**From:** [bbeier9013@aol.com](mailto:bbeier9013@aol.com)  
**To:** [DSDIntern](#); [Ben Semple](#); [Omar](#); [Hanna Veal](#)  
**Subject:** Re: Questions about the resubmittals from 06/05/2024 REPLY  
**Date:** Thursday, July 25, 2024 5:10:00 PM  
**Attachments:** [Side Elevations.pdf](#)  
[34TH ST. TOWNHOUSES L1.0 Landscape Plan \(12\).pdf](#)  
[image006.png](#)  
[image005.png](#)  
[image008.png](#)  
[image007.png](#)  
[image002.png](#)  
[image001.png](#)  
[image004.png](#)  
[image009.png](#)

34TH STREET TOWNHOUSES  
 211, 219, 227, AND 235 W. 34TH ST.  
 GARDEN CITY, IDAHO 83714

LANDSCAPE PLAN	
PROJECT	24004
DATE	5/23/24
DRAWN BY	BSS
CHECKED BY	BSS
SHEET	L1.0

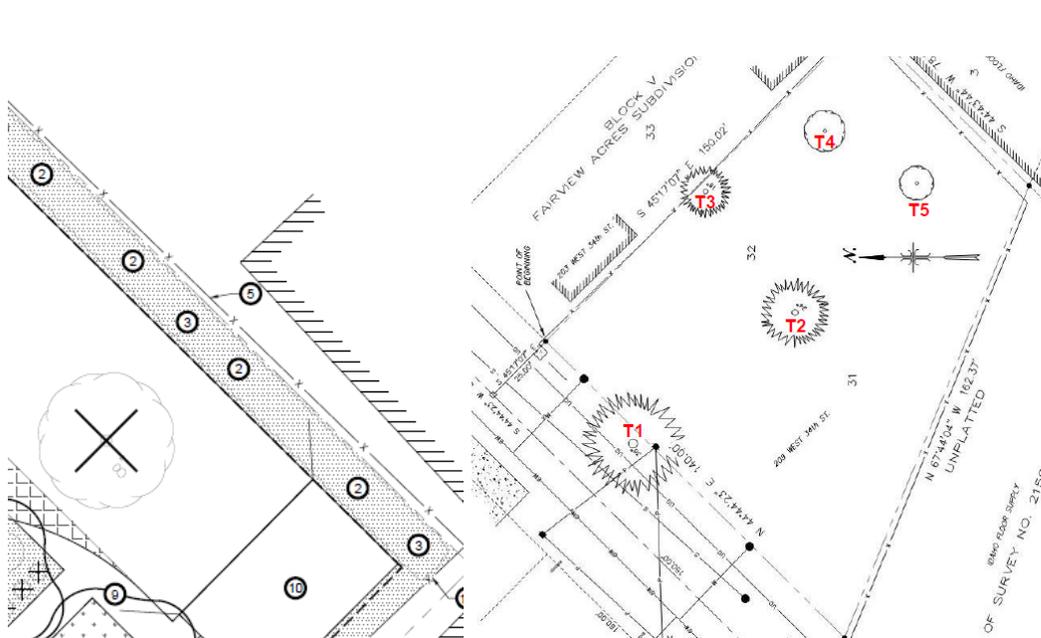
5. Number 2 in the plans means "RETAIN AND PROTECT EXISTING TREE". The first screenshot points to the northeastern part of the site. These trees are not in the arborist's report (arborist's report on the second screenshot). Please clarify.

5. Callout #3 in those locations was placed incorrectly. Vegetation to remain (callout #2) along the NE property line shown in the screenshot from the City are large shrubs, not trees, therefore were not included in the arborist evaluation or report. Those large shrubs are to remain, along with other trees on the site that are indicated with callout #3. SEE ATTACHED REVISED LANDSCAPE PLAN below.

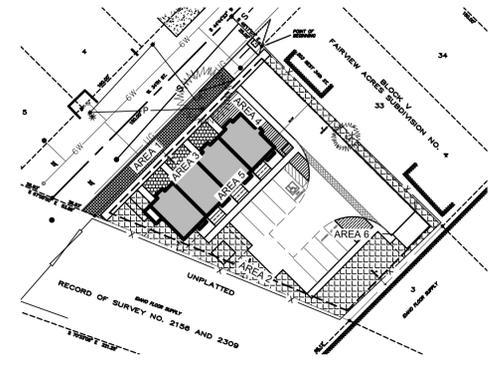
4. The site configuration has been changed and the landscape has been reduced. Provide calculations for 8-4L-5 Open Space Standards for multi-family development.

4. Open space calculations added to landscape requirement notes and callouts 16 and 17

added to indicate areas of open space complying with the code section for size and dimension.

SHEET  
 A6.0

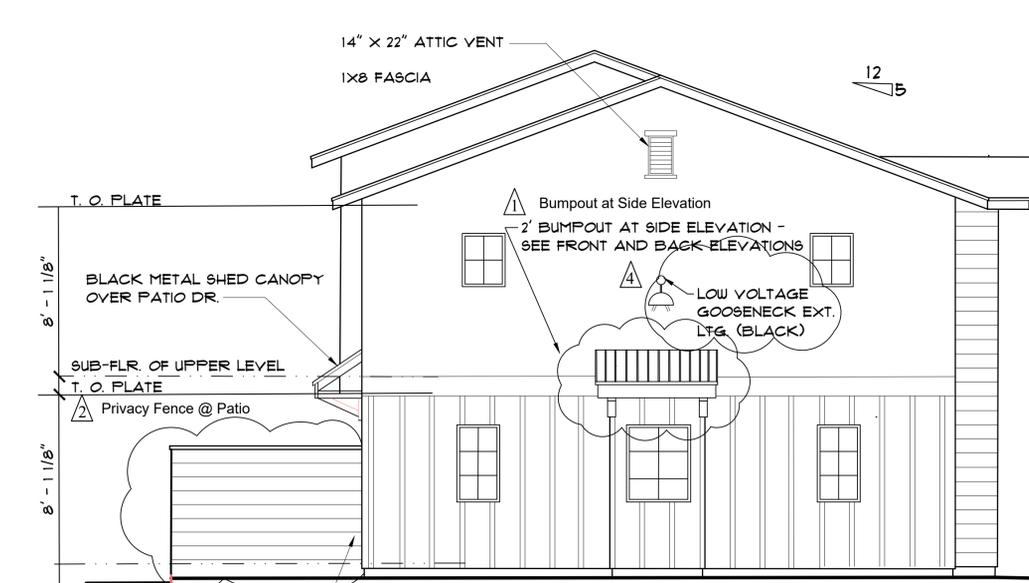
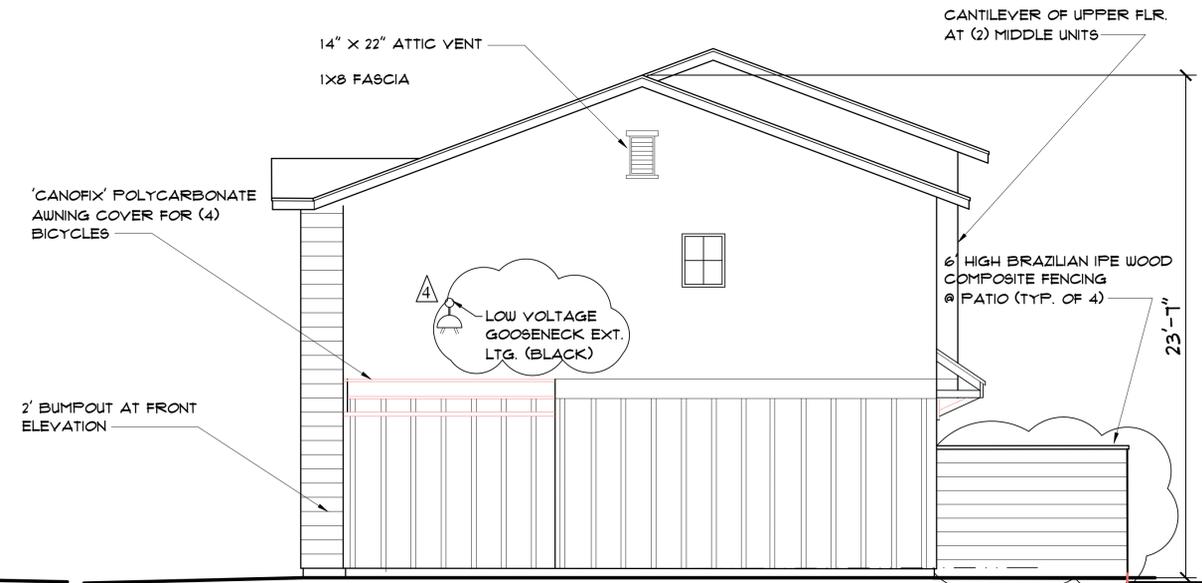
3. Please provide side elevation (east/west). The side elevation document that we received is a duplicate of the front/back elevations. **SEE ATTACHED SIDE ELEVATION PLAN below.**
